COMMENT RESPONSE DOCUMENT

EASA PAD No. 15-128R1

Figure A-FSAAA - Sheet 01

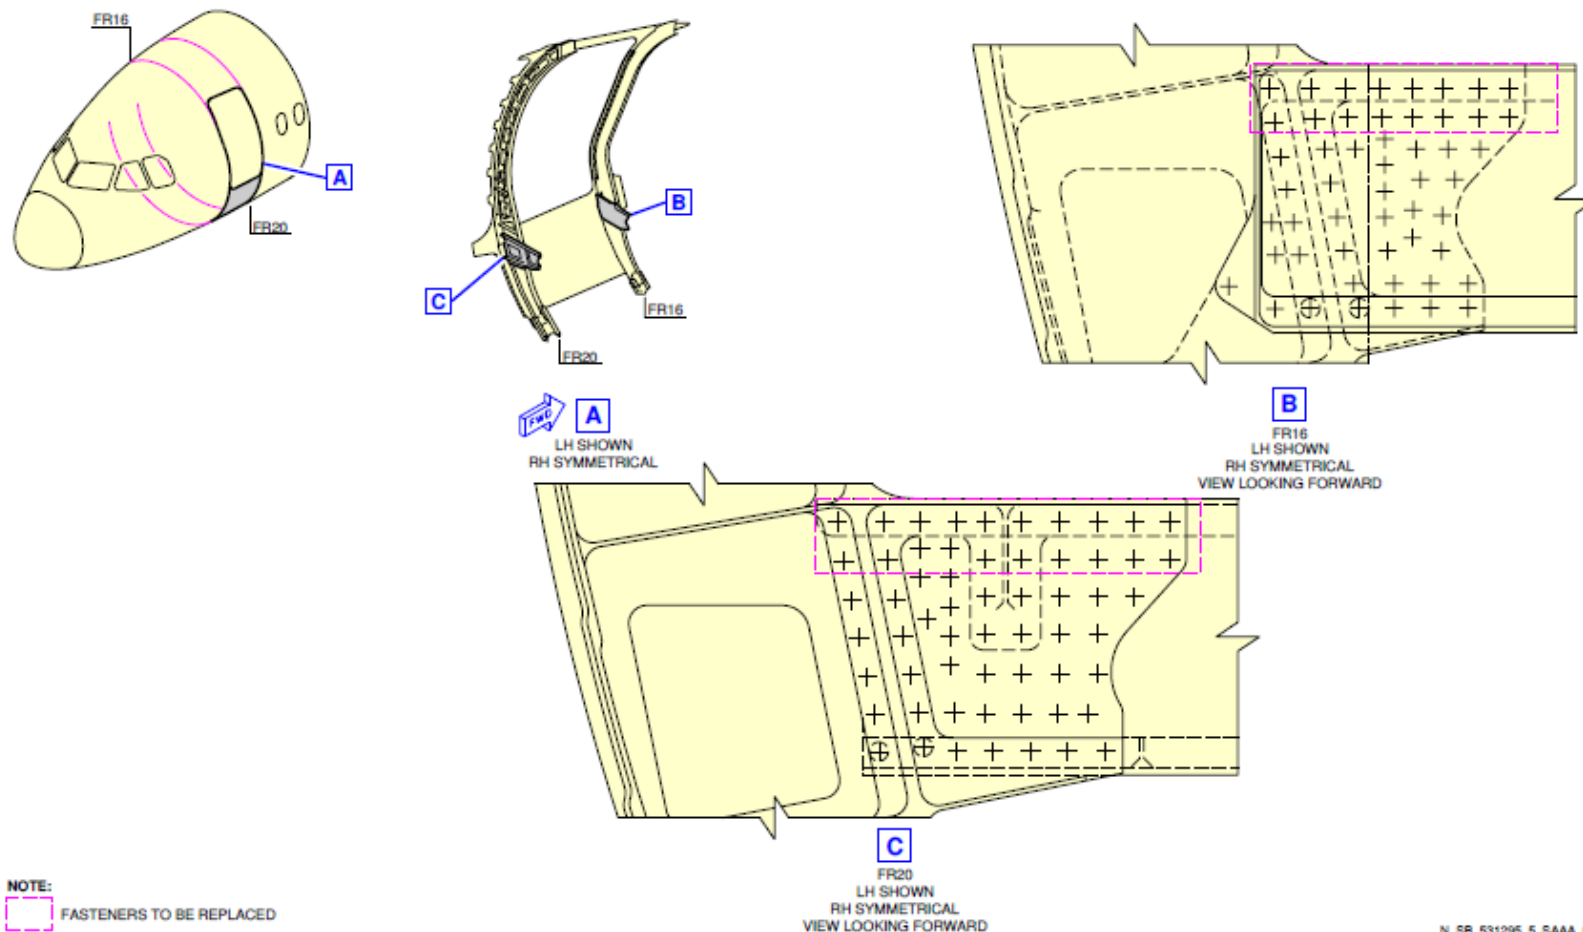
Good day,
Only one comment this time:
Could you please specify the area for which acc. paragraph 4 no fasteners EN6114 have to be installed during previous repair? I suppose you mean the modification area as stipulate in SB A320-53-1295 but I would appreciate if you clarify this in the final AD.

Comments agreed: the installation of the wrong countersunk is limited to the SB area. The AD has been updated accordingly.
